SUBJECT: ISSUANCE OF AMENDMENTS - JOSEPH M. FARLEY NUCLEAR PLANT,
 UNITS 1 AND 2 (TAC NOS. M99136 AND M99137)

The Nuclear Regulatory Commission has issued the enclosed Amendment No. 133 to Facility Operating License No. NPF-2 and Amendment No. 125 to Facility Operating License No. NPF-8 for the Joseph M. Farley Nuclear Plant, Units 1 and 2. The amendments change the Technical Specifications (TS) in response to your submittal dated June 30, 1997, as supplemented September 25, 1997. The revision supplemented the TS Bases to discuss credit for boraflex panels in the revised criticality analysis. The staff found that the supplement did not change the conclusions of the proposed no significant hazards consideration; therefore, renotification of the Commission's proposed determination of no significant hazards consideration was not necessary.

The amendments change the Farley TS to incorporate requirements necessary to change the basis for prevention of criticality in the fuel storage pool. The change eliminates the credit for Boraflex as a neutron absorbing material in the fuel storage pool criticality analysis. The change also establishes an alternate method for maintaining the recomm

Figure 3.7-1 Fuel Assembly Burnup Limit Requirements For All Cell Storage

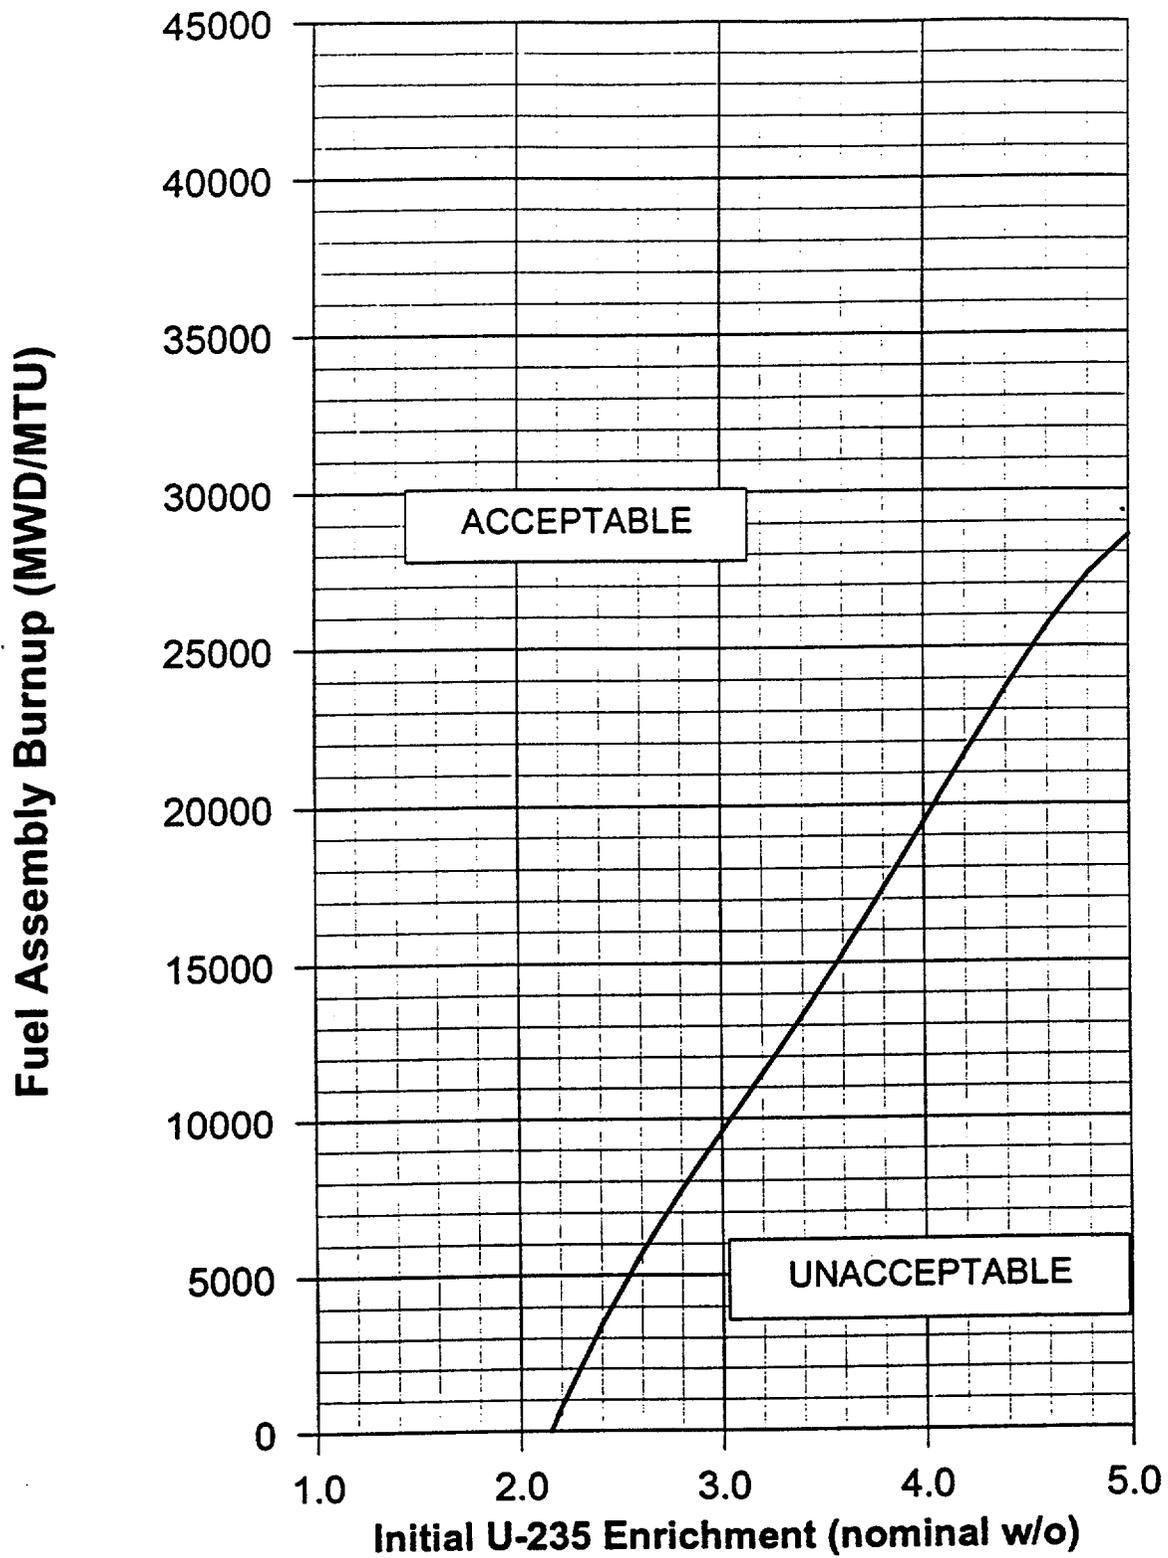
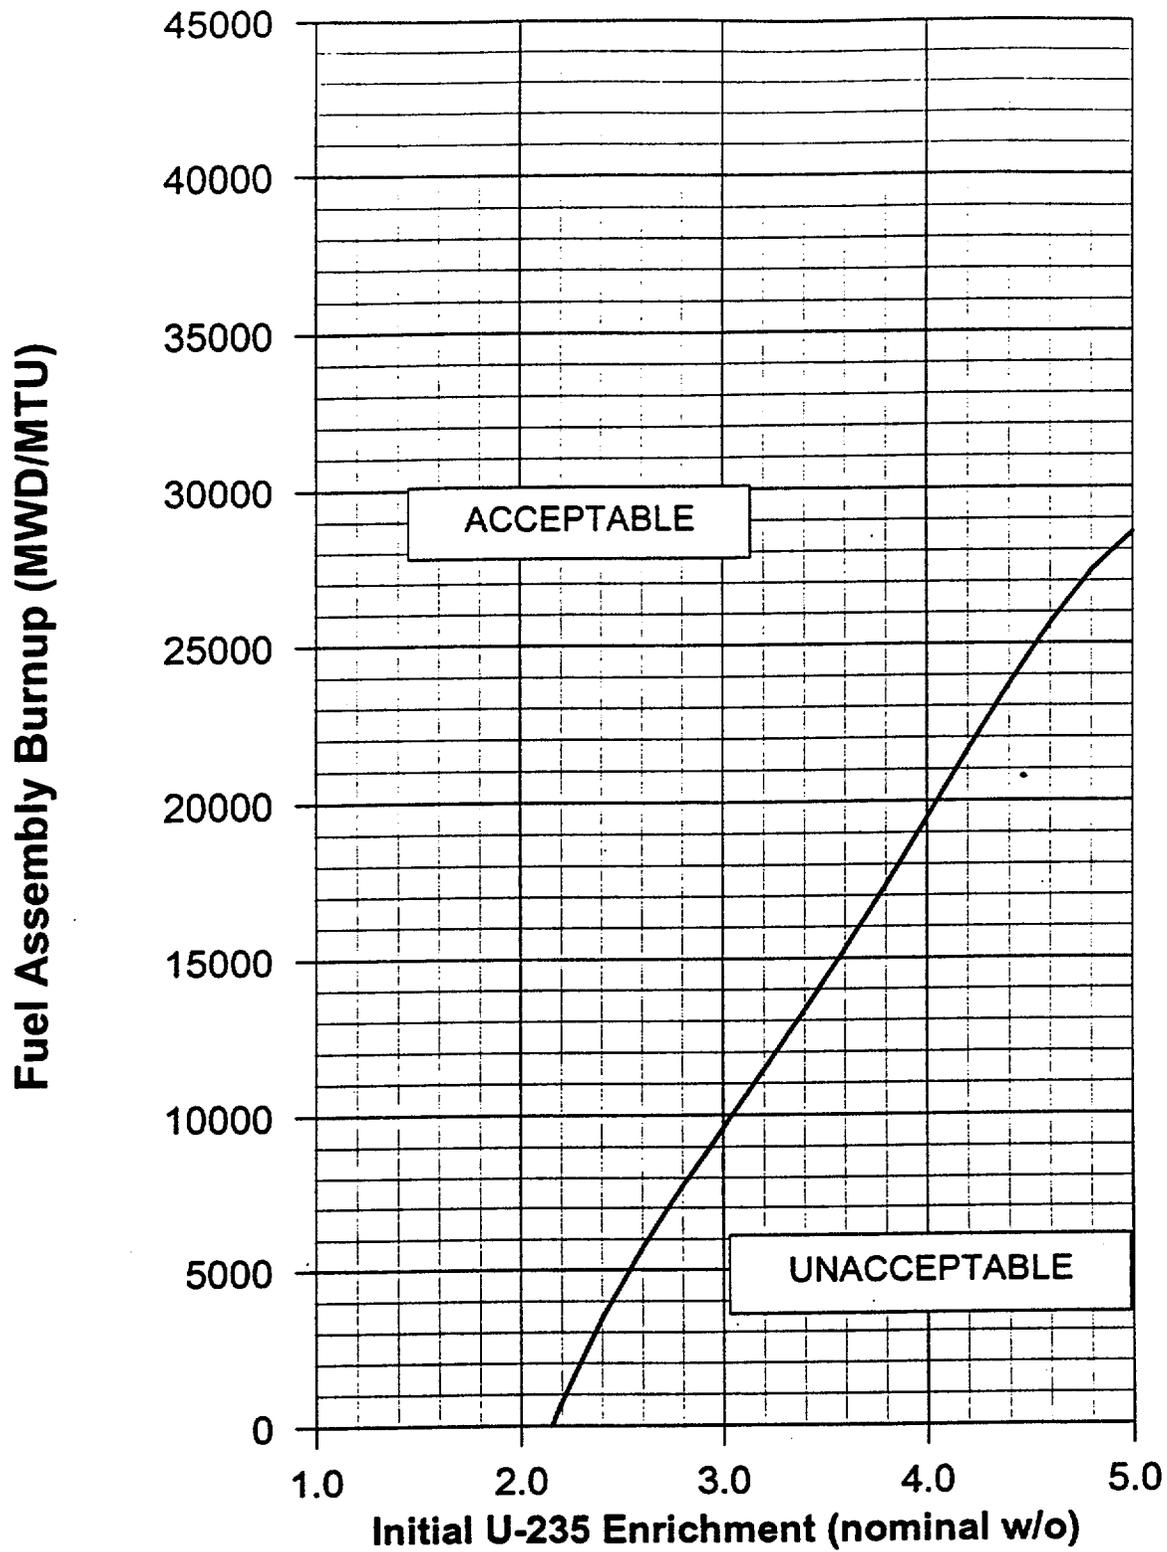
3.7.14 The combination of initial enrichment and burnup of each fuel assembly stored in the spent fuel storage pool shall be within the Acceptable Burnup Domain of Figure 3.7-1, or shall be stored in accordance with Specification 5.6.1.1.

- e. New or partially spent fuel assemblies with a combination of discharge burnup and initial enrichment in the "acceptable range" of Figure 3.7-1 may be allowed unrestricted storage in the spent fuel racks (also shown as the All Cell Storage configuration in Figure 5.6-2).

Westinghouse 17X17 fuel assemblies with nominal enrichments less than or equal to 2.15 w/o U-235 can be stored in any cell location as shown in Figure 5.6-2. Fuel assemblies with initial nominal enrichments greater than these limits must satisfy a minimum burnup requirement as shown in Figure 3.7-1.

Assemblies with initial nominal enrichments no greater than 2.15 w/o U-235 can be stored in any cell location. Fuel assemblies with initial nominal enrichments greater than this and up to 5.0 w/o U-235 must satisfy a minimum burnup requirement as shown in TS Figure 3.7-1.

Figure 5.6-1 Fuel Assembly Burnup Limit Requirements for Low Enrichment (L)
 Assembly of the Burned/Fresh Checkerboard Storage (see Figure 5.6-2)

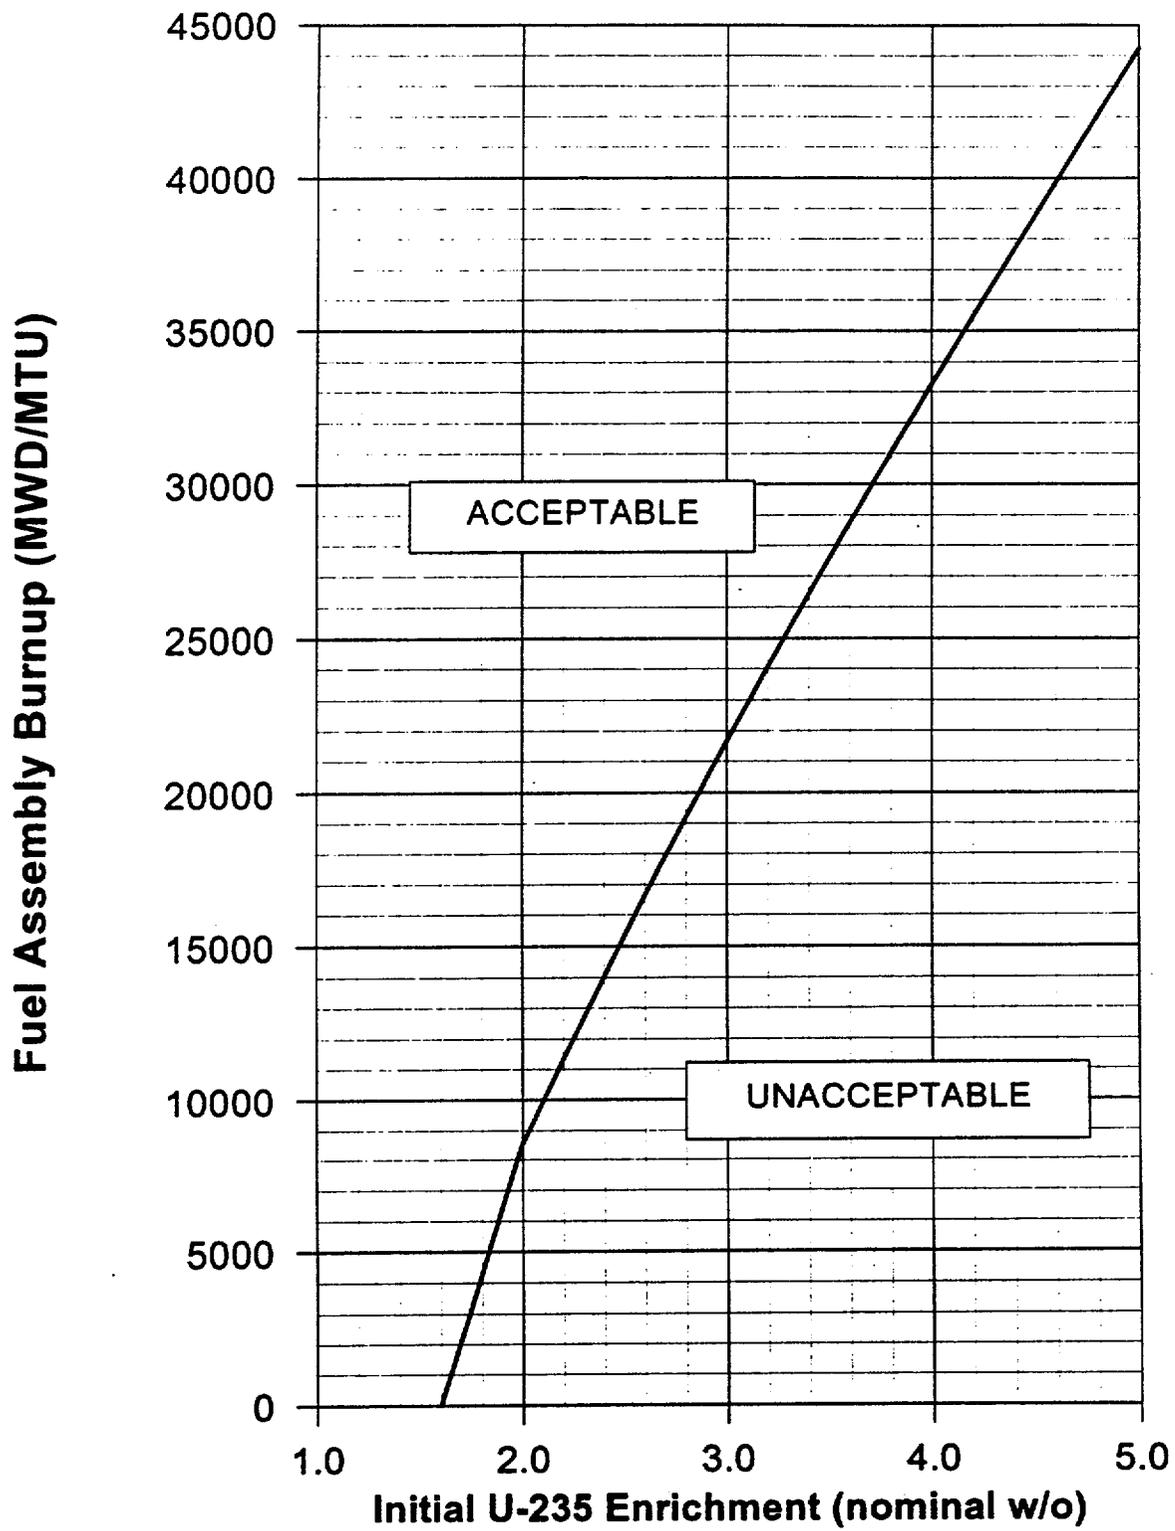
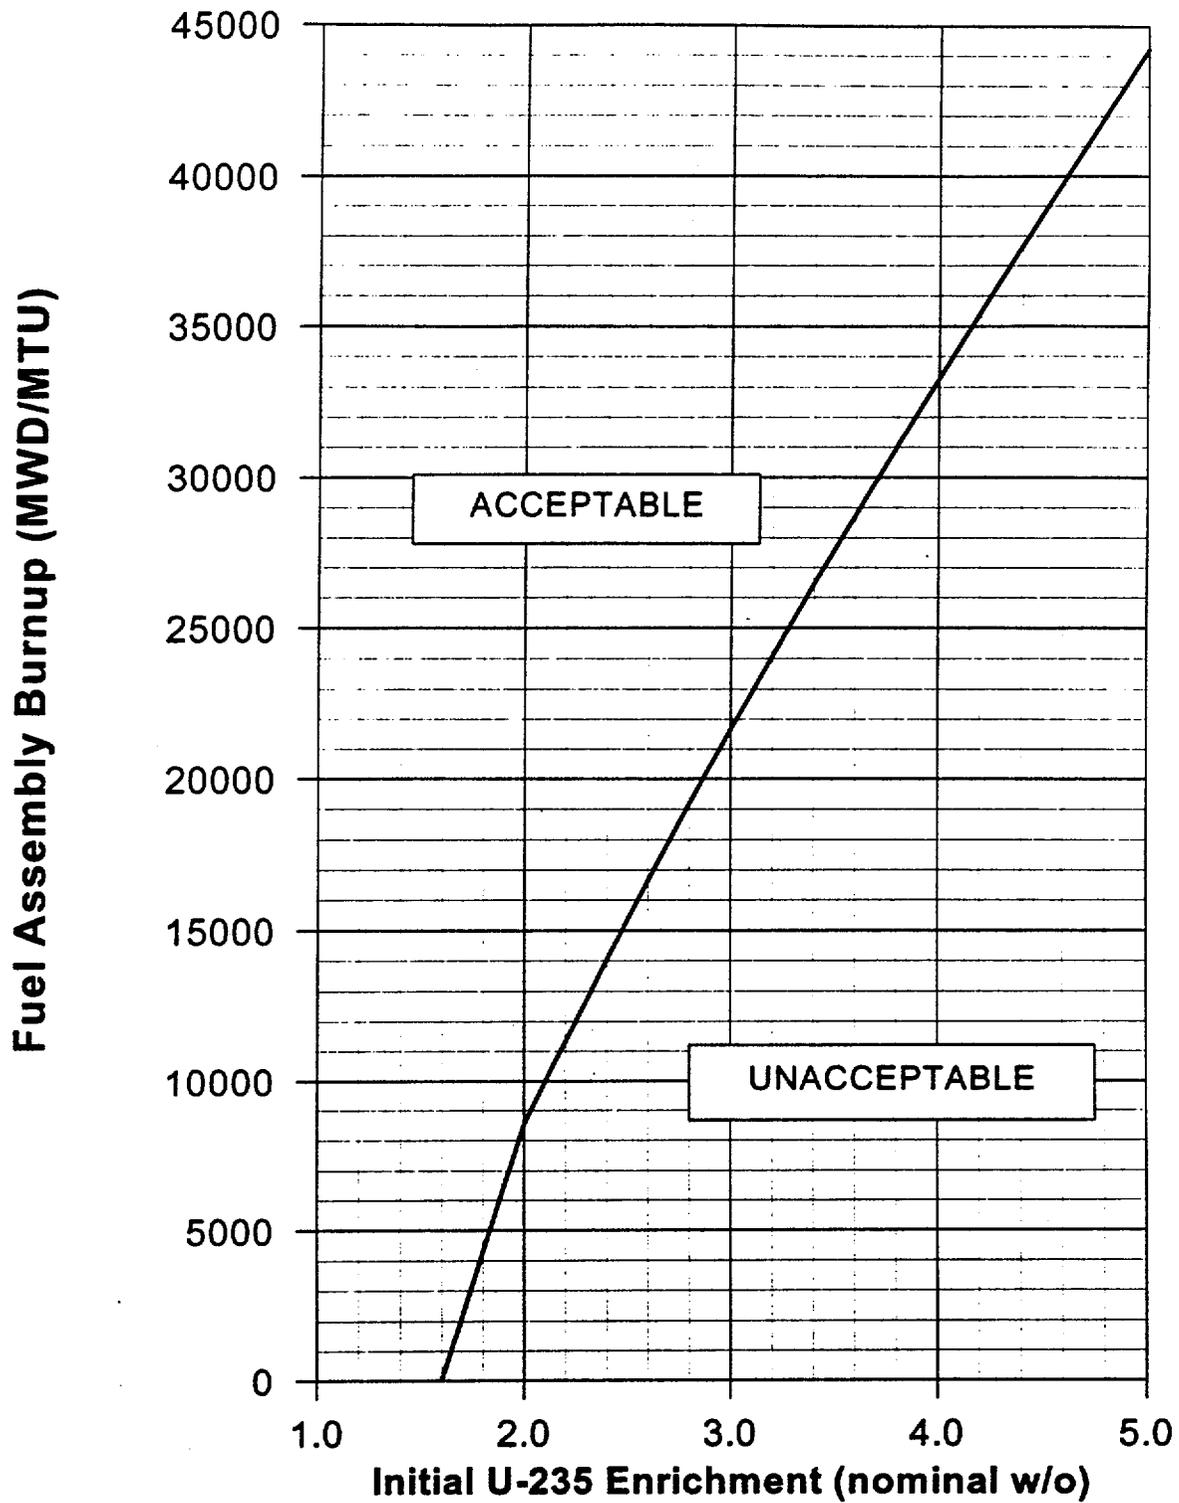
- f. New or partially spent fuel assemblies with a combination of discharge burnup and initial enrichment in the "unacceptable range" of Figure 3.7-1 will be stored in compliance with Figures 5.6-1 through 5.6-5. The high enrichment fuel assemblies shown in the Burned/Fresh Storage configuration in Figure 5.6-2, with maximum nominal enrichments greater than 3.9 w/o U-235, shall contain sufficient integral burnable absorbers such that a maximum reference fuel assembly k_{∞} less than or equal to 1.455 at 68°F is maintained.

minimum burnup requirement for higher initial enrichments as shown in Figure 5.6-1. The fourth fuel assembly must have an initial nominal enrichment less than or equal to 3.9 w/o U-235, or satisfy a minimum Integral Fuel Burnable Absorber requirement for higher initial enrichments to maintain the reference fuel assembly k_{∞} less than or equal to 1.455 at 68° F.

Assemblies can be stored in a burned/fresh 2 x 2 checkerboard arrangement consisting of three fuel assemblies with an initial nominal enrichment no greater than 1.6 w/o U-235 and one assembly with an initial nominal enrichment no greater than 3.9 w/o U-235. Fuel assemblies with initial enrichments greater than this and up to 5.0 w/o U-235 must satisfy a minimum burnup requirement as shown in TS Figure 5.6-1 (low-enrichment assemblies) or must satisfy a minimum IFBA requirement that maintains a maximum reference fuel assembly k_{∞} less than or equal to 1.455 at 68°F (high-enrichment assembly).
